Adran yr Economi a'r Seilwaith
Department for Economy and Infrastructure

File Ref WG/REB/OBJ0270-8 GWT/Bakere

Response to Objector's Evidence: Richard Bakere (Gwent Wildlife Trust)

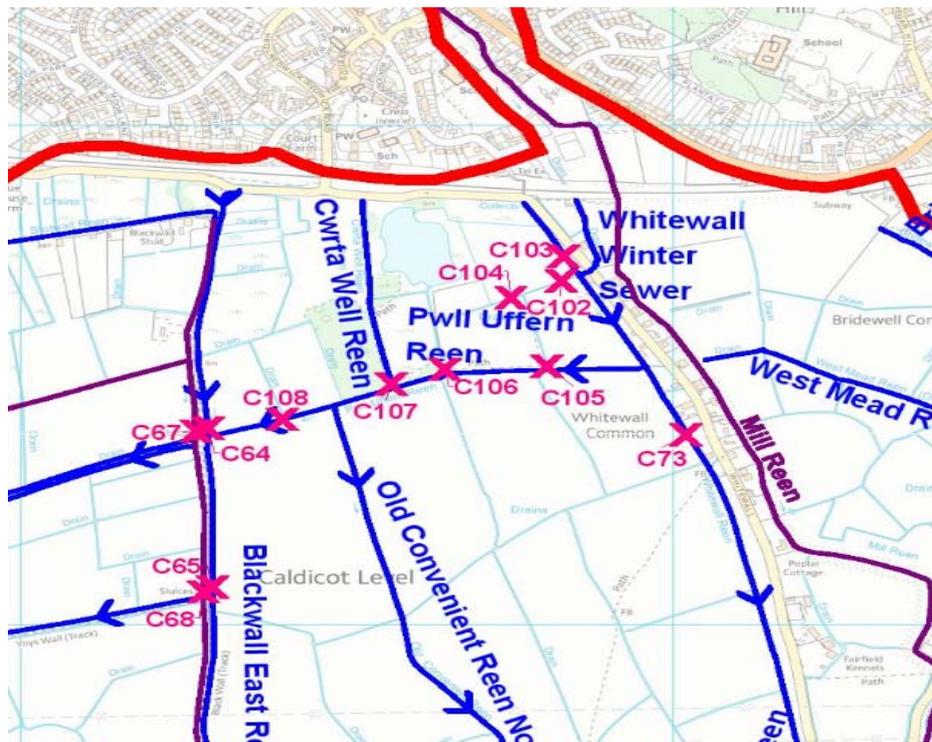
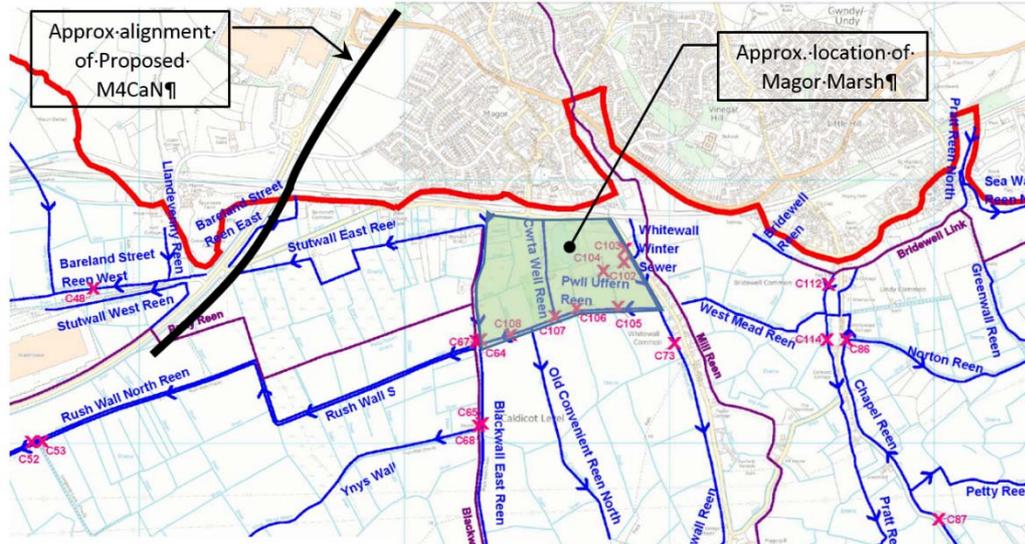
- 2.3.1. Response to **Point 4** (Considers that the proposal risks the very essence of the Nature Reserve at Magor Marsh by threatening the water that creates the wetland habitat in the reserve by disruption of ground water flow to the spring in the nature reserve which is vital to maintaining the high water levels on the whole nature reserve):

8. Michael Vaughan (Flood Consequences) confirms that the project team has assessed the hydrological setting of the nature reserve by reference to plans held by the former Caldicot and Wentlooge Internal Drainage

Board, (now Natural Resources Wales). An extract from the plans is shown below.

9. The plans indicate that the surface water flow regime within the nature reserve is to the south of Magor and from the east. These areas are remote from, and unlikely to be impacted by the proposed Scheme. In conclusion, construction works associated with the proposed Scheme will

not impact the flow of surface water that supports the wetland habitat within nature reserve.
